Minutes – Executive Policy Committee – October 18, 2017

Item No. 2 Request to Amend Development Agreement Conditions For File DASZ 3/2016 (AG 3/2016) (Transcona Ward)

Title: **REQUEST TO AMEND DEVELOPMENT AGREEMENT CONDITIONS FOR FILE DASZ 3/2016 (AG 3/2016)**

APPENDIX "B" – PROPOSED SCHEDULE G MAP TO AG 3/2016

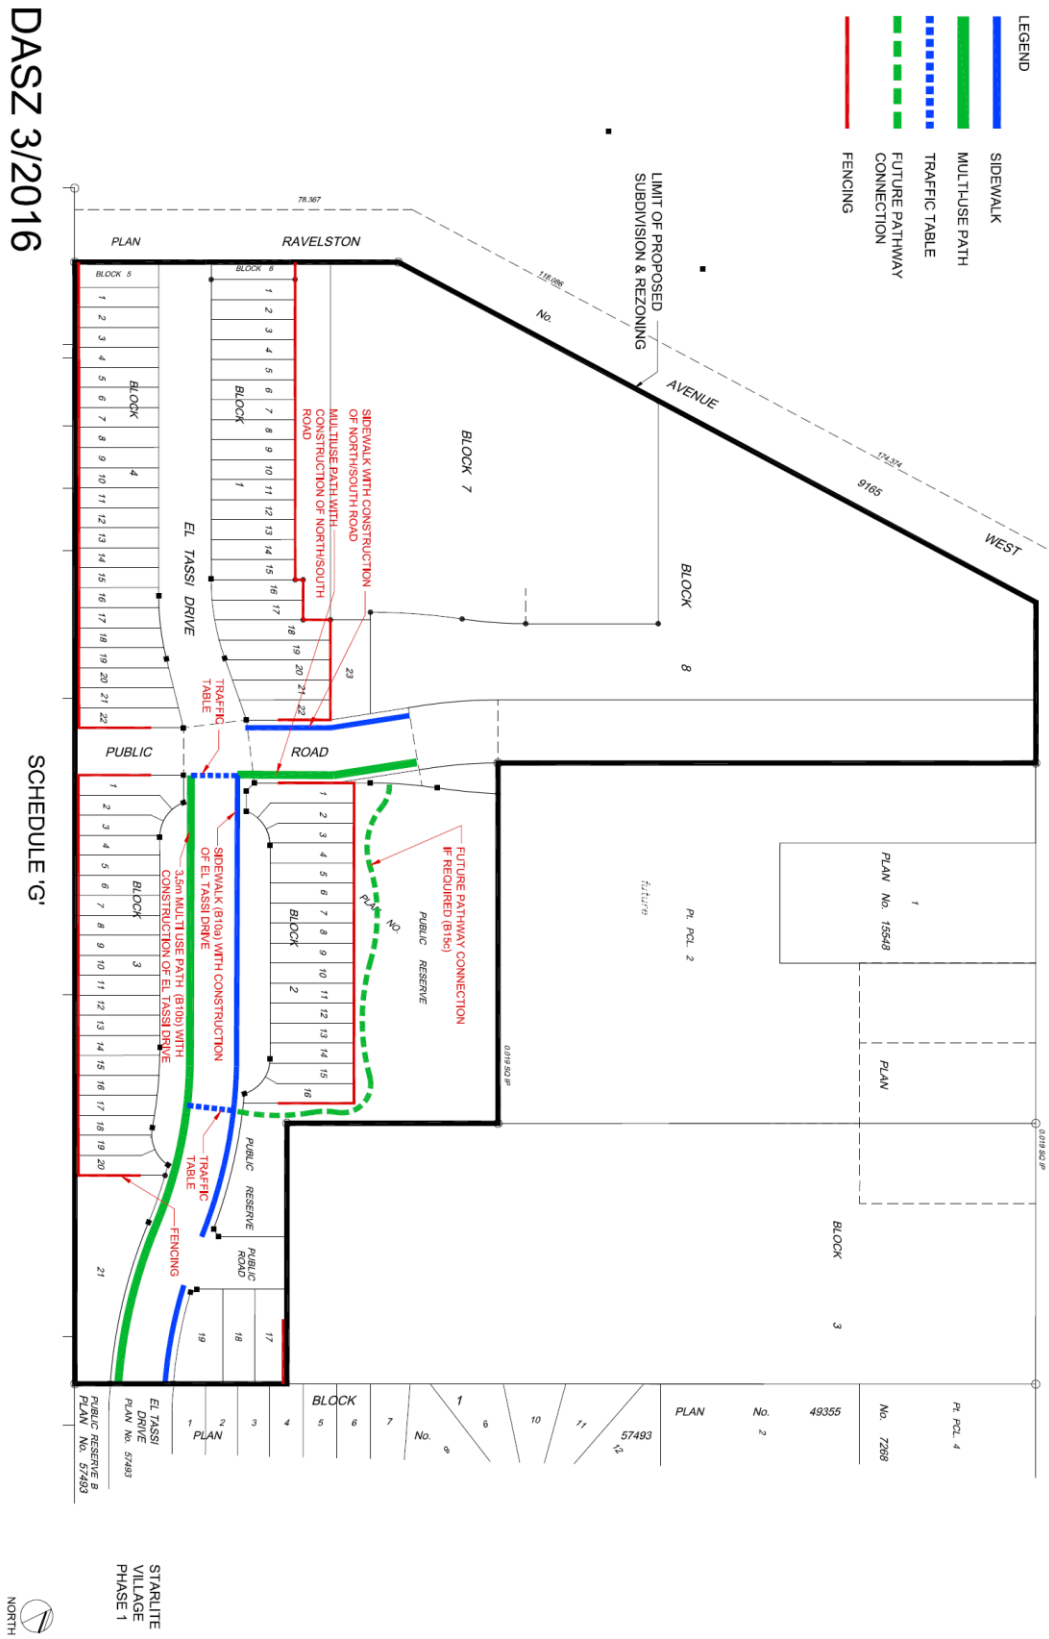
2. That the Developer's request to amend Development Agreement (AG 3/16) to delete and replace the Schedule "G" Map with an amended Schedule "G" listed as Appendix B of this report, be approved, subject to the following:

Pursuant to Development Agreement AG 3/2016, the Developer is required to, at no expense to the City, construct an east-west multi-use pathway along the proposed extension of El Tassi Drive. The Developer is requesting that this condition be amended so that the pathway would only extend to the future north/south road (identified as “Public Road” in Appendix “B” to this report).

The Winnipeg Public Service is opposed to this request as this pathway is required under the Transcona West Area Structure Plan and is the only east-west walking and cycling path between Reenders Drive and Concordia Avenue with connectivity to the only crossing of Lagimodiere Boulevard at Almey Avenue.

> Comments from Public Works
> Public Works does not support the proposed amendment. The multi-use path along El Tassi Avenue is required under Map 4 of the Transcona West Area Structure Plan, By-law No. 215/2006.
> Public Works considers the multi-use path along El Tassi Avenue important because it is the only east/west walking and cycling path between Reenders Drive and Concordia Avenue with connectivity to the only crossing of Lagimodiere Boulevard at Almey Avenue.
> Furthermore, the multi-use path along El Tassi Avenue will serve pedestrians and cyclists travelling to and from Crocus Meadows and neighbouring developments to the east and northeast to the crossing of Lagimodiere Boulevard at Almey Avenue.

2) **Schedule G**
Delete Schedule 'G' and replace with attached Schedule 'G'.

Based on the above comments, it is recommended that the Developer's request to amend the requirement for a pathway, specifically to amend Development Agreement (AG 3/2016) Clause 10., b) of Schedule "C" and Schedule "G", be denied.

APPENDIX C

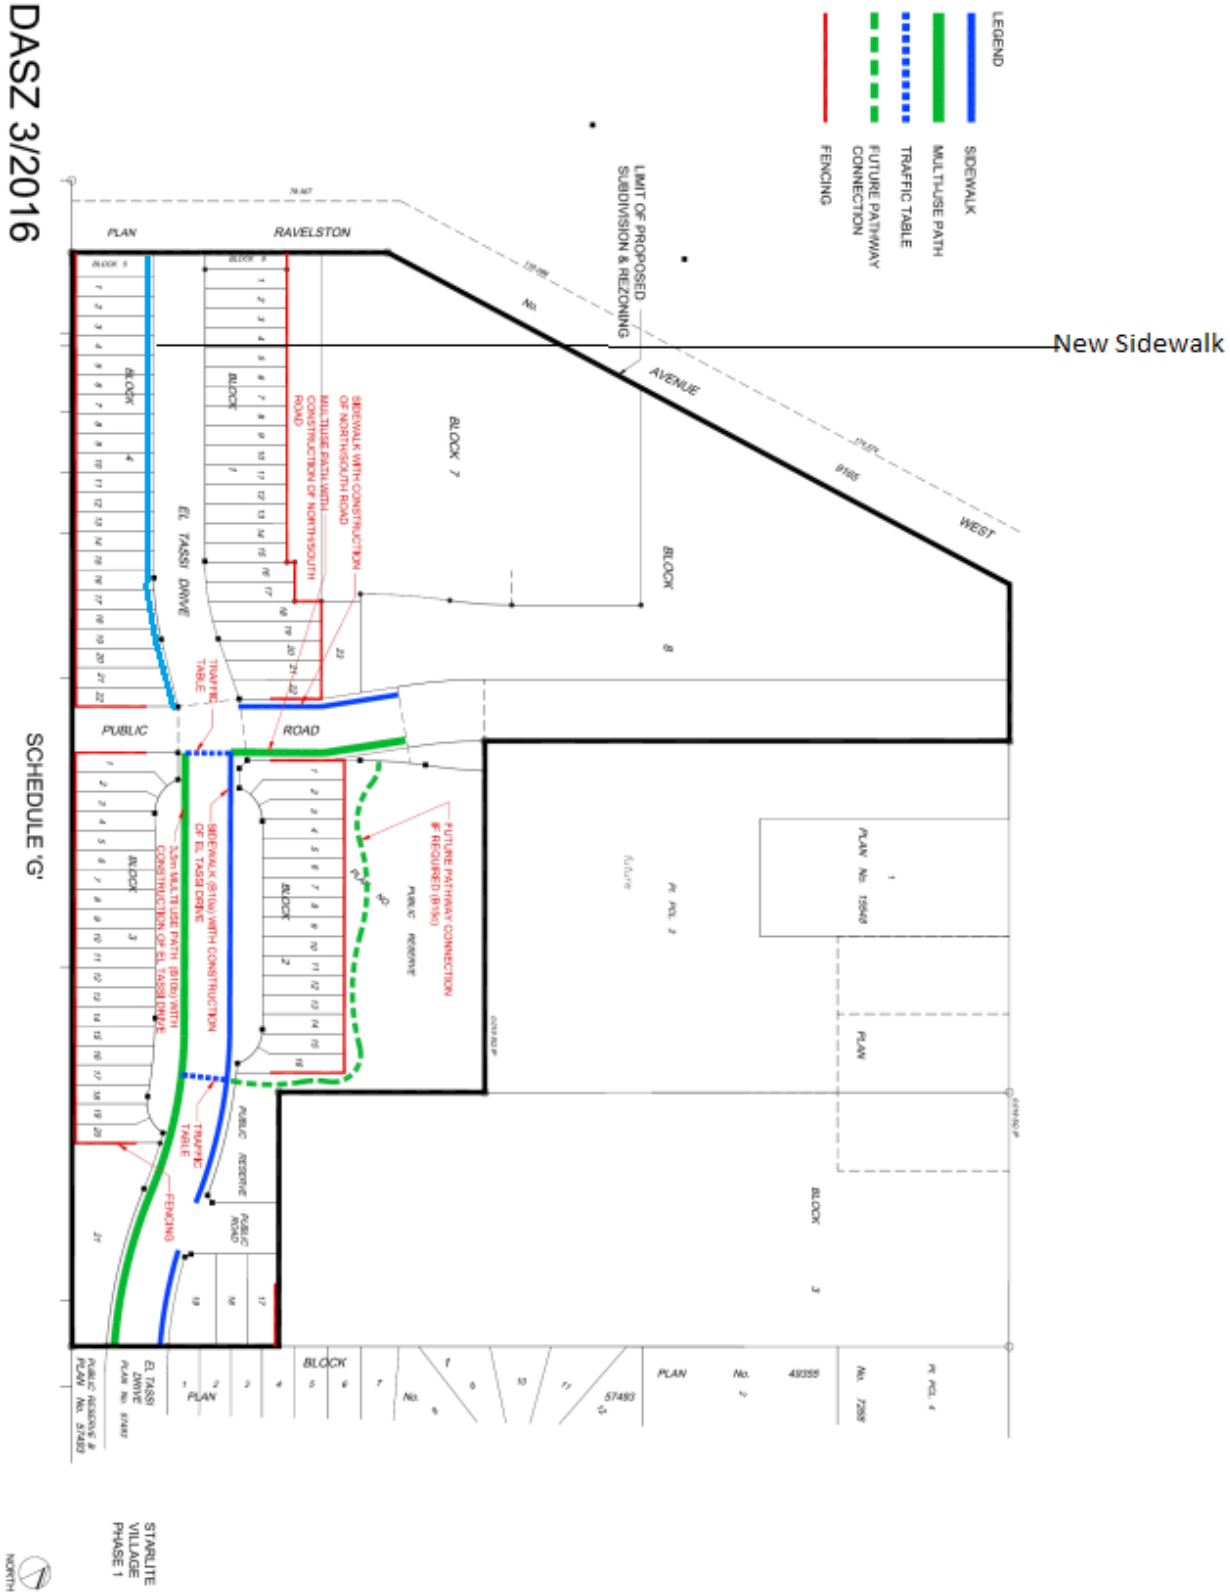
A. That the Developer install a sidewalk on the south side of El Tassi Drive, along Blocks 4 and 5, as outlined in blue on Appendix C.
